Access Compliance Report

Public Rights-of-Way

Intersection ID: 53235	Main Street: EVERGREEN_DR	Cross Street: DOLLY_MADISON_RD	Location: NE
ADA ID: 0E7917116BE7	Ramp Type: Perp	Initial Pass/Fail: Fail	Overall Compliance: No
		Severity Score: 22.5

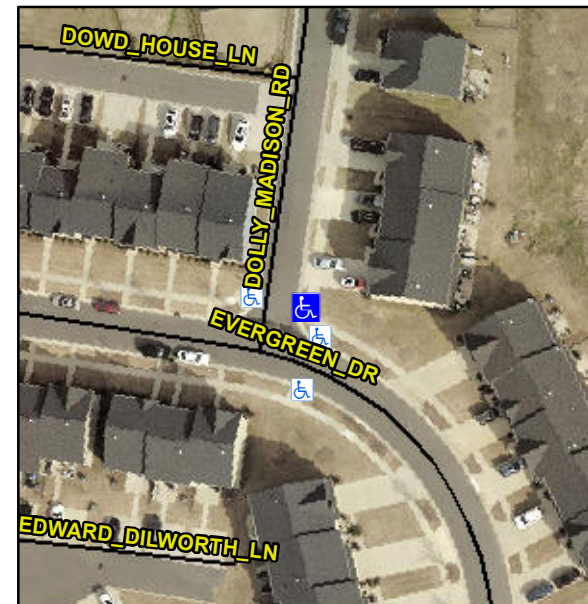
R304.5.1, R304.2.2, R304.5.3

Compliance	Description	Data	Compliance	Description	Data
N/A	Ramp Length (in)	36.0	No	Ramp Slope (%)	10.0
No	Ramp Width (in)	47.0	No	Ramp XSlope (%)	2.8
N/A	Flare Type LT	N/A	N/A	Flare Type RT	N/A
N/A	Flare Slope LT (%)	N/A	N/A	Flare Slope RT (%)	N/A
N/A	Flare Traversable LT?	N/A	N/A	Flare Traversable RT?	N/A
N/A	Landing Length (in)	N/A	N/A	DWS Provided?	N/A
N/A	Landing Width (in)	N/A	N/A	DWS Contrast?	N/A
N/A	Landing Slope (%)	N/A	N/A	DWS Length (in)	N/A
N/A	Landing X Slope (%)	N/A	N/A	DWS Full Width?	N/A
N/A	Landing Curb? (Y/N)	N/A	N/A	DWS Offset (in)	N/A
N/A	Shared Landing?	N/A			
N/A	Gutter Ponding?	N/A	N/A	Gutter Slope (%)	N/A
N/A	Gutter Lip Ht (in)	N/A	N/A	Gutter X Slope (%)	N/A
N/A	Painted X Walk1?	No	N/A	Painted X Walk2?	N/A
	X Walk 1 Direction	To W		X Walk 2 Direction	N/A
N/A	X Walk 1 Width (in)	N/A	N/A	X Walk 2 Width (in)	N/A
	X Walk 1 Slope (%)	2.3		X Walk 2 Slope (%)	N/A
	X Walk 1 X Slope (%)	0.5		X Walk 2 X Slope (%)	N/A

Remove & Replace Entire Ramp.
